ADDENDUM 01 - COVER SHEET

COKE BUILDING / WAREHOUSE FIRE SPRINKLER SYSTEM

PROJECT #4850-02-26

ADDENDUM 01 ISSUED: 07/07/2026

5. Final Addendum Issue Date?

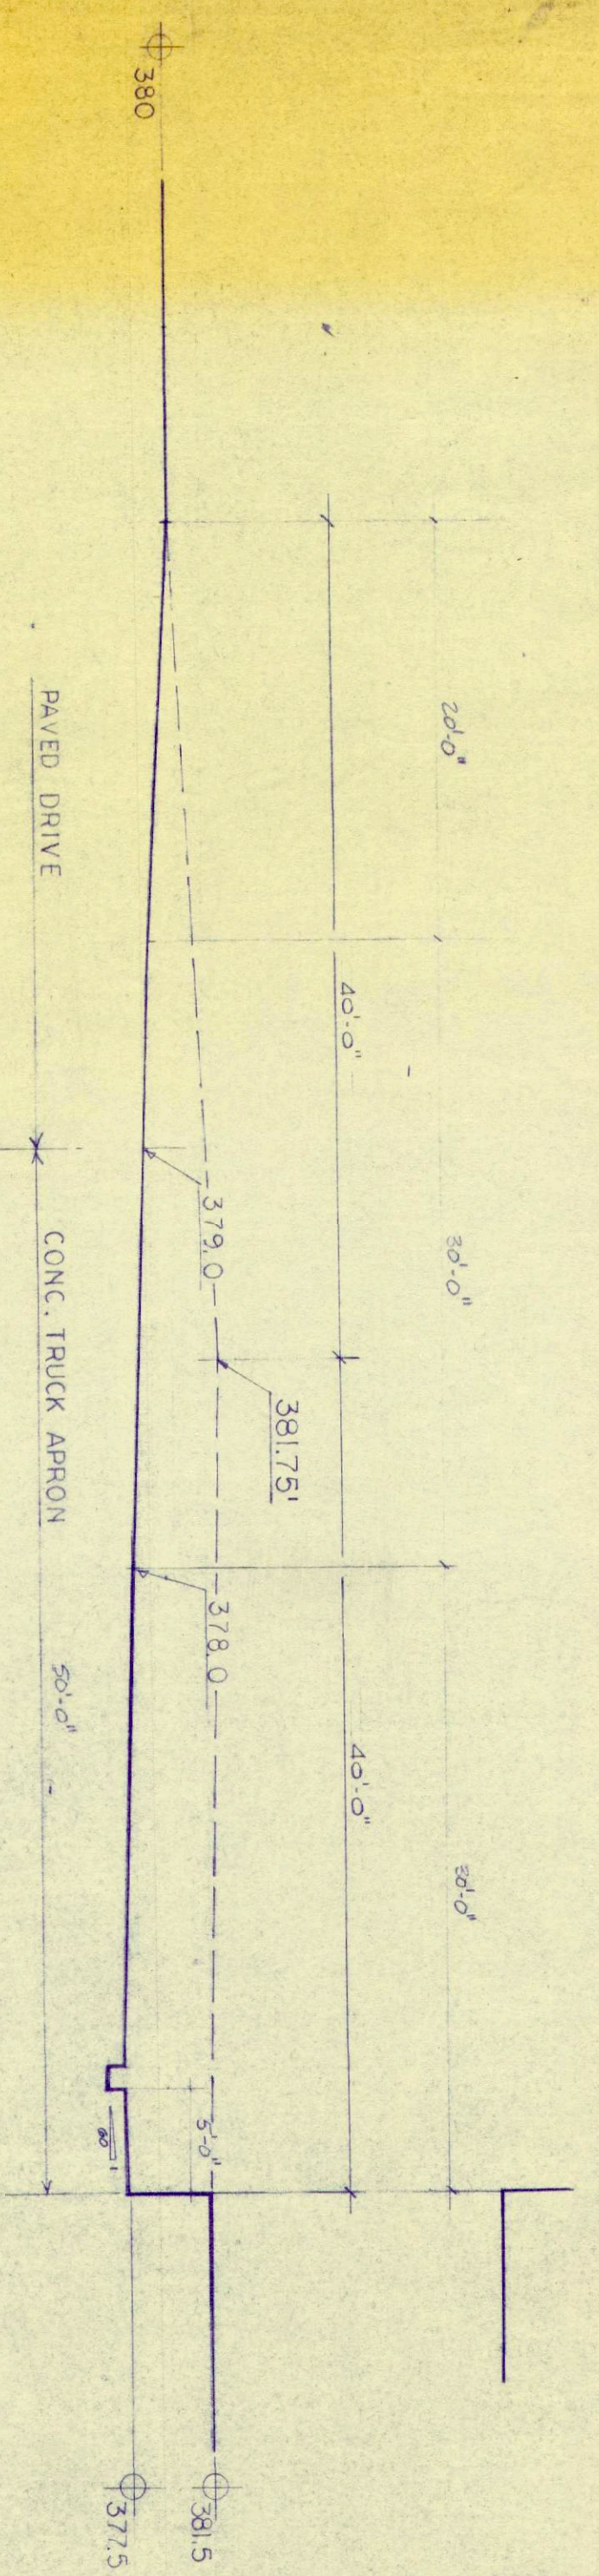
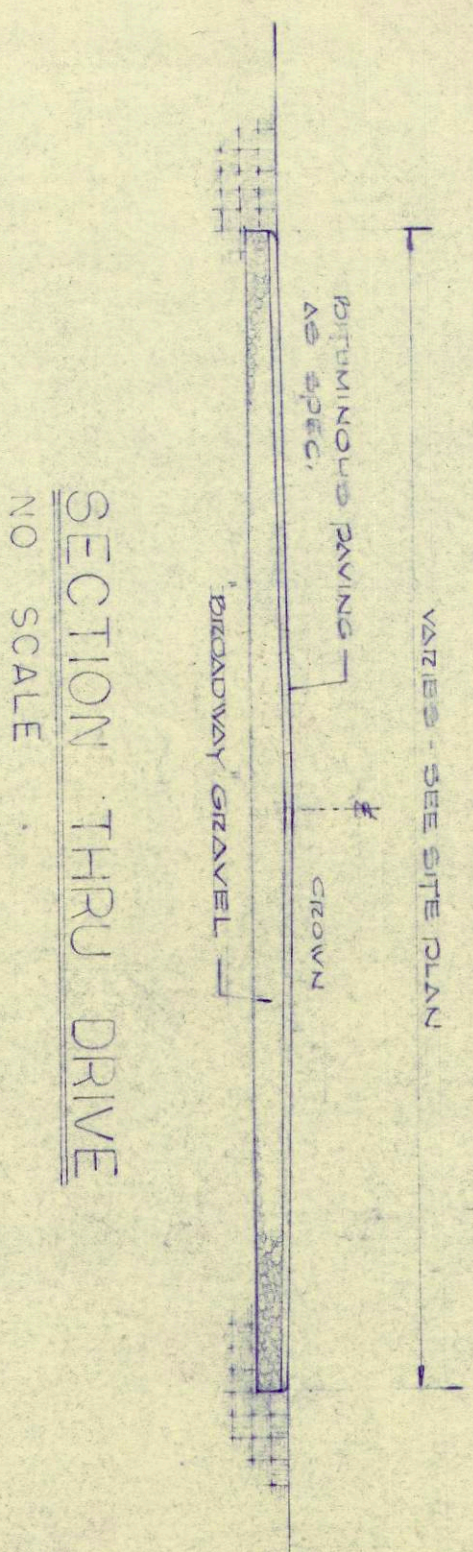
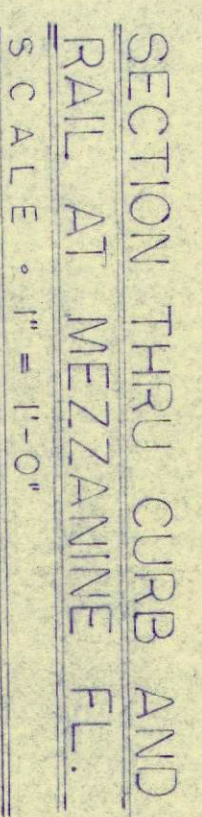
2. Mezzanine Drawing?

ANSWER: See attached drawing (A-3 Mezzanine Floor Plan) for mezzanine level
